Bid Addendum

Bid Title: P.O.Hoffer Water Treatment Facility Glenville Lake Water Treatment Facility Post-Filter GAC Adsorption Facilities Contract No.67

Addendum Number: 2

ADDENDUM NO. 2 – TECHNICAL SPECIFICATIONS AND DRAWINGS

PO HOFFER INTERMEDIATE PUMP STATION AND GAC FACILITY- AIRFLOW DIAGRAM

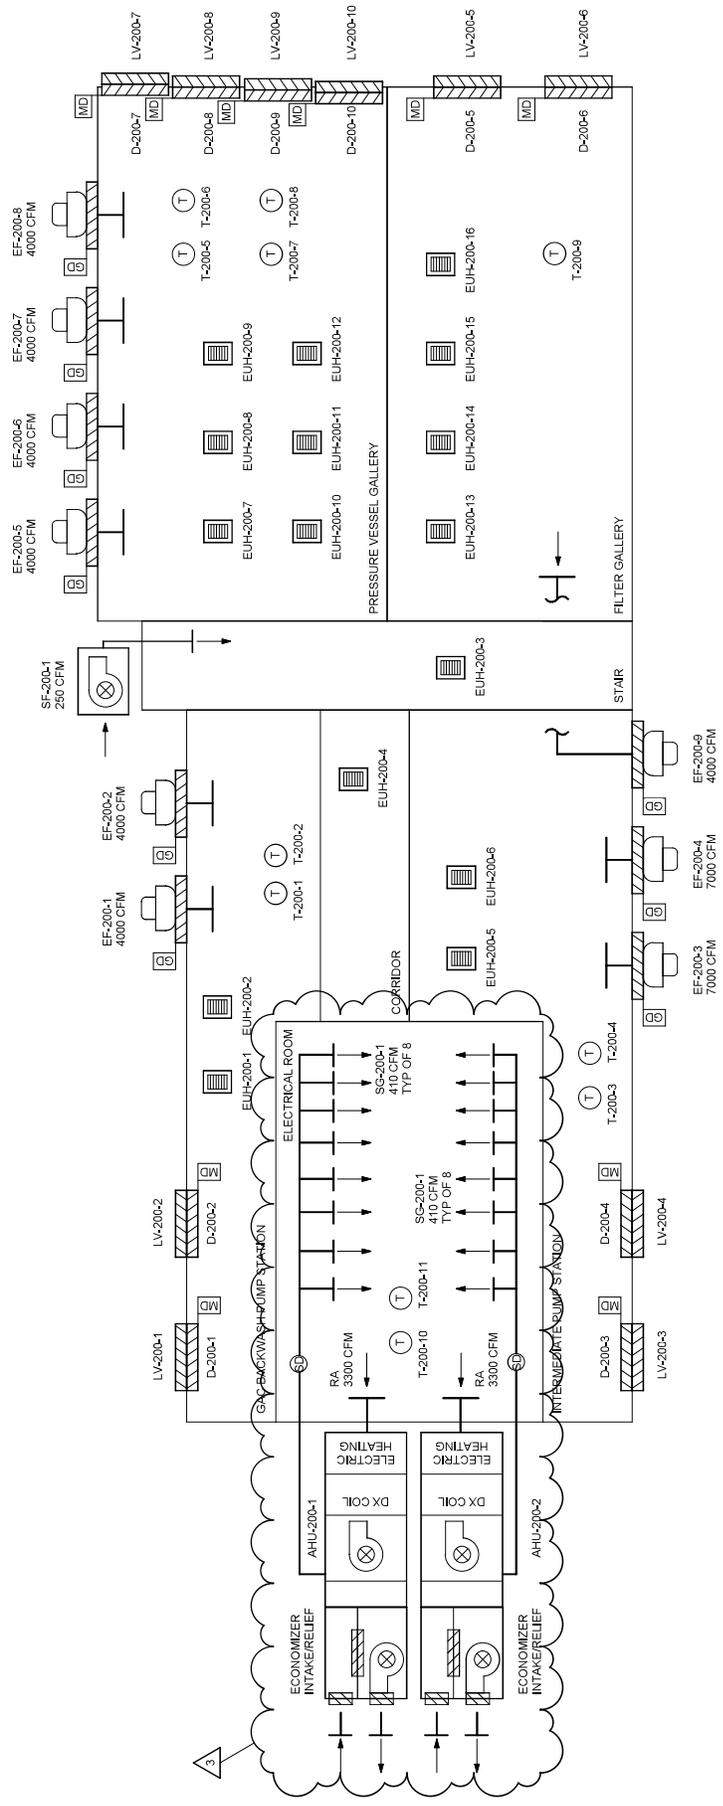
- H02 Revised DRG schedule to include updated supply air grille sizes. Revised Air Flow Diagram to reflect the updated CFMs, as shown in **Attachment #16**.

GLENVILLE LAKE WTF ELECTRICAL BUILDING - AIRFLOW DIAGRAM

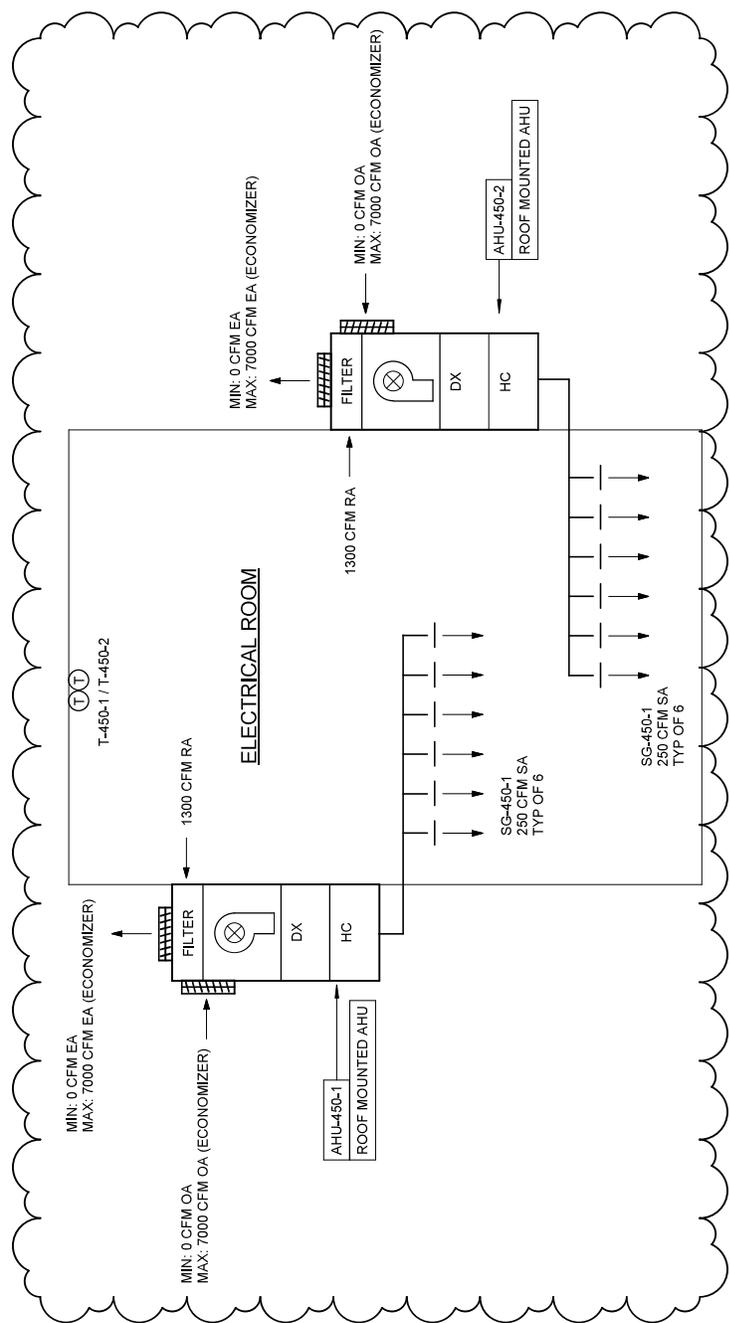
- H03 Revised Packaged AHU schedule to reflect the updated air handler selection, as shown in **Attachment #17**.
- H05 Revised DRG schedule to include updated supply air grille sizes. Revised Air Flow Diagram to reflect the updated CFMs, as shown in **Attachment #18**.

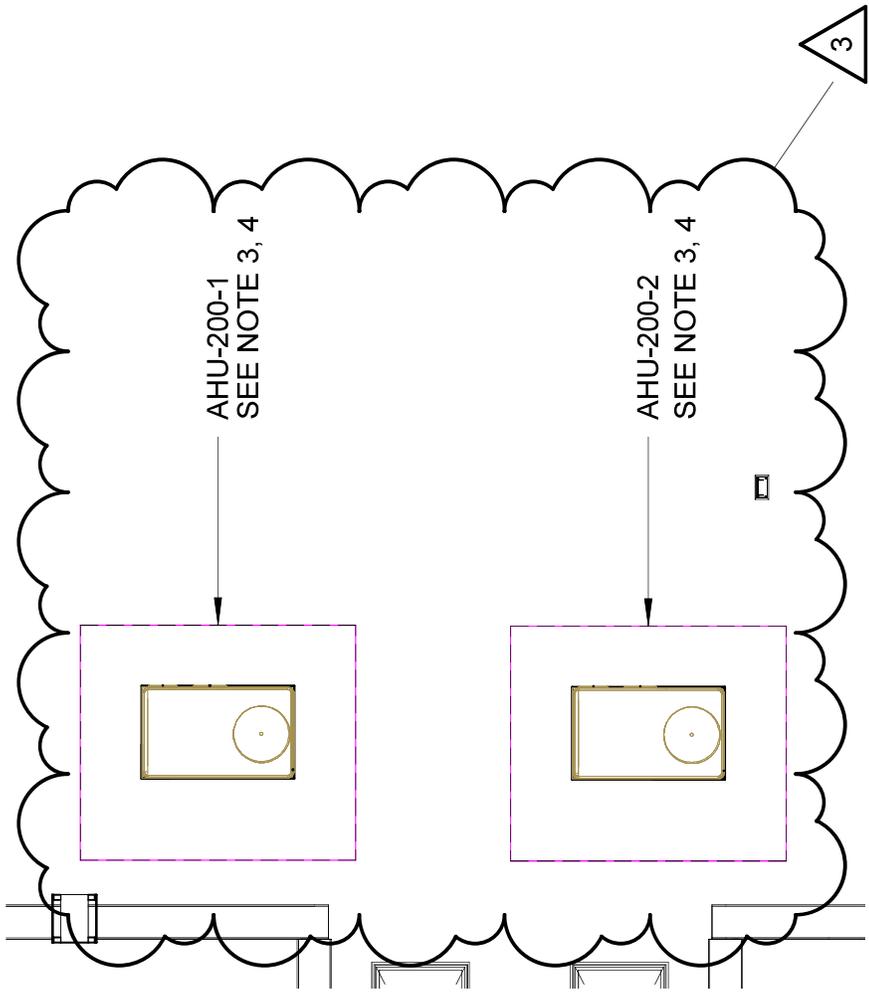
- H201 Revised AHU-200-1/AHU-200-2 unit dimensions, and supply & return air ductwork sizes, as shown in HVAC INTERMEDIATE PLAN, included in **Attachment #21**.

ATTACHMENT NO. 22	BY DCH	GLENVILLE LAKE AND P.O. HOFFER WATER TREATMENT FACILITIES	SHEET 1 OF 1
ADDENDA NO. 002	DATE 01/2026	CITY OF FAYETTEVILLE, NORTH CAROLINA	CONTRACT NUMBER 67
		PUBLIC WORKS COMMISSION	HAZEN JOB NUMBER 30402-067
			REFER TO CONTRACT DRAWING NUMBER H450

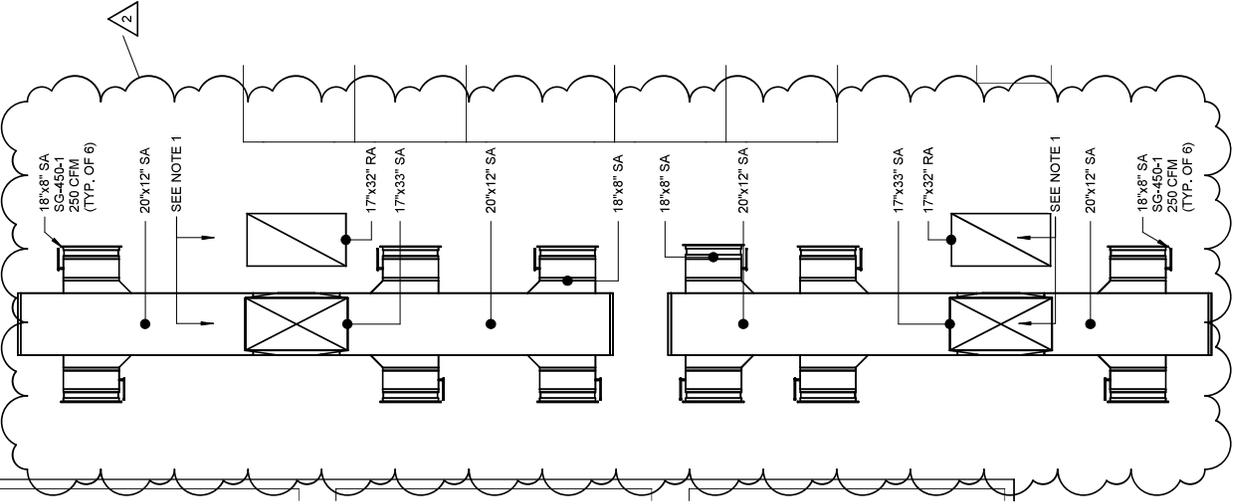
- H450 Revised AHU-450-1/AHU-450-2 unit dimensions, and supply & return air ductwork sizes. Revised supply air grille sizes in the electrical building, as shown in HVAC TOP PLAN, included in **Attachment #22**.

ATTACHMENT NO. 23	BY DCH	GLENVILLE LAKE AND P.O. HOFFER WATER TREATMENT FACILITY	CONTRACT NUMBER 67	SHEET 1 OF 1
APPENDA NO. 002	DATE 01/2026	CITY OF FAYETTEVILLE, NORTH CAROLINA PUBLIC WORKS COMMISSION	HAZEN JOB NUMBER 30402-067	REFER TO CONTRACT DRAWING NUMBER H451

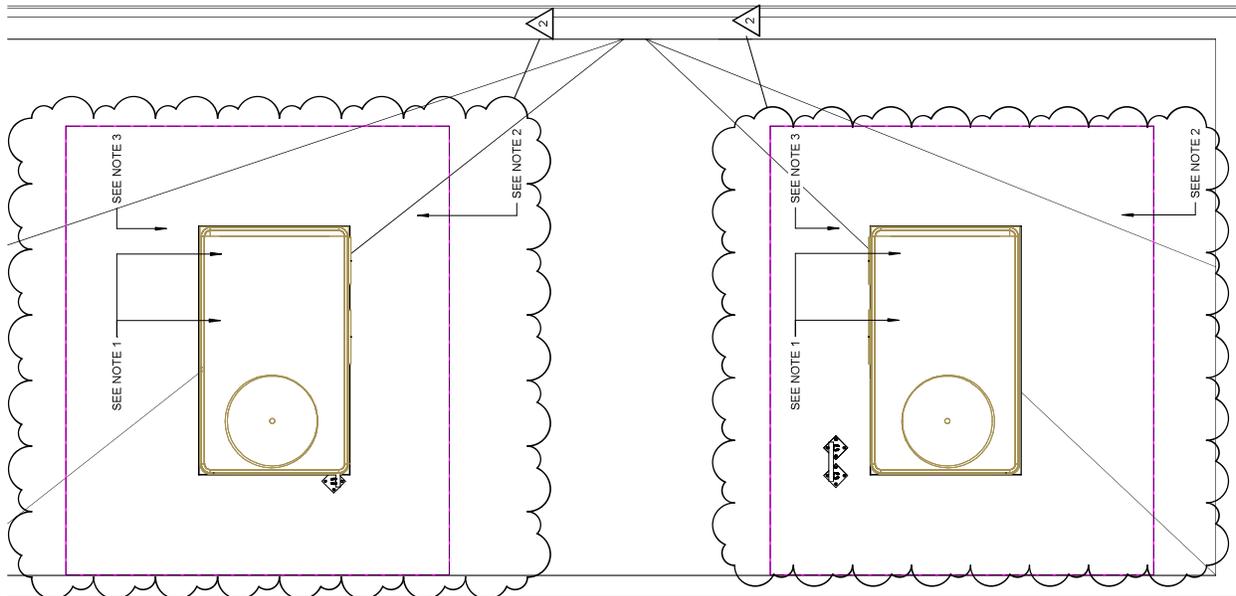
- H451 Revised AHU-450-1/AHU-450-2 unit dimensions, and supply & return air ductwork sizes, as shown in HVAC ROOF PLAN, included in **Attachment #23**.

ATTACHMENT NO. 24	BY DCH	GLENVILLE LAKE AND P.O. HOFFER WATER TREATMENT FACILITIES	CONTRACT NUMBER 67	SHEET 1 OF 1
ADDENDA NO. 002	DATE 01/2026	CITY OF FAYETTEVILLE, NORTH CAROLINA	HAZEN JOB NUMBER 30402-067	REFER TO CONTRACT DRAWING NUMBER 1401
PUBLIC WORKS COMMISSION

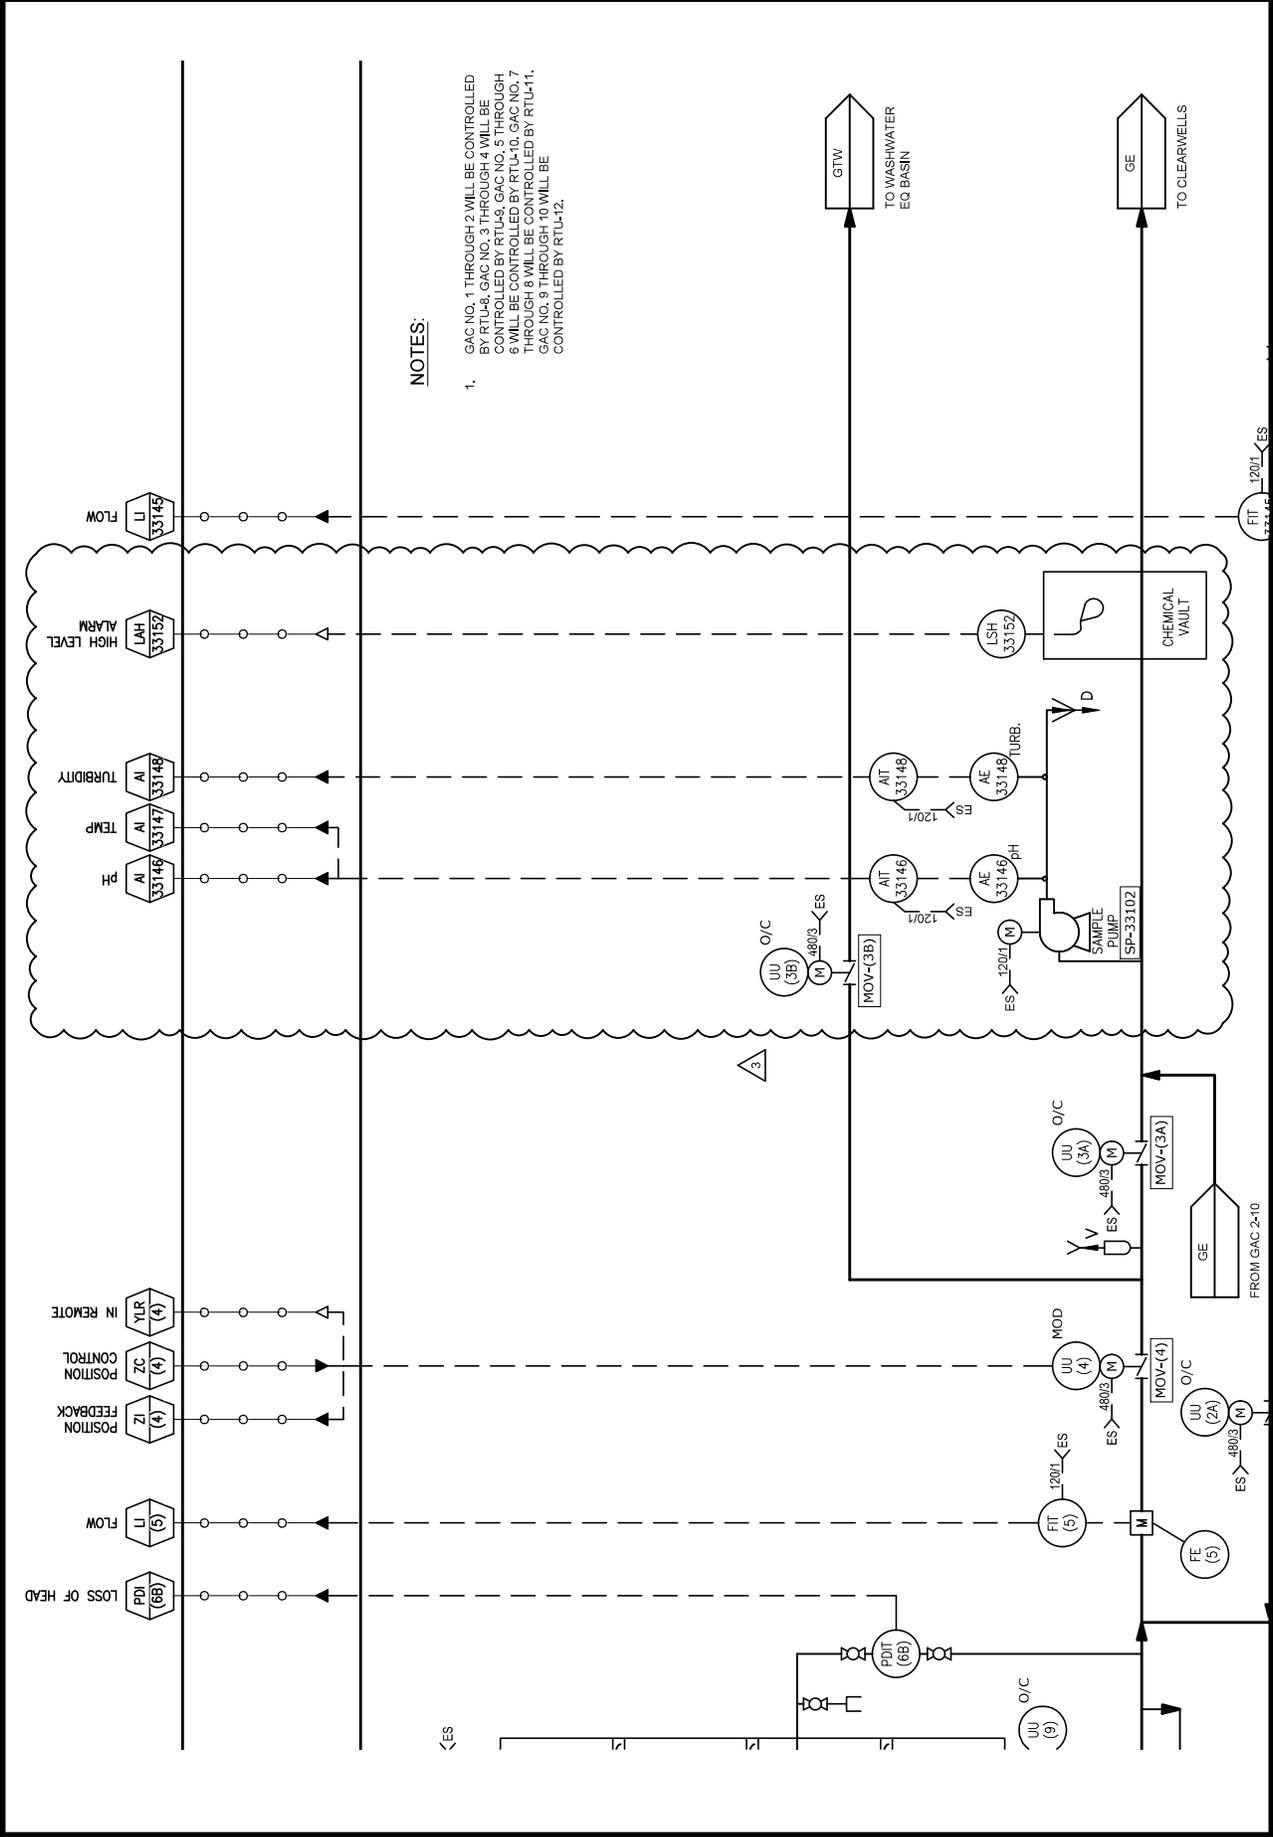
I401 Revised SP-33102 location to accurately show sample port before chemical vault injection, included in **Attachment #24**.
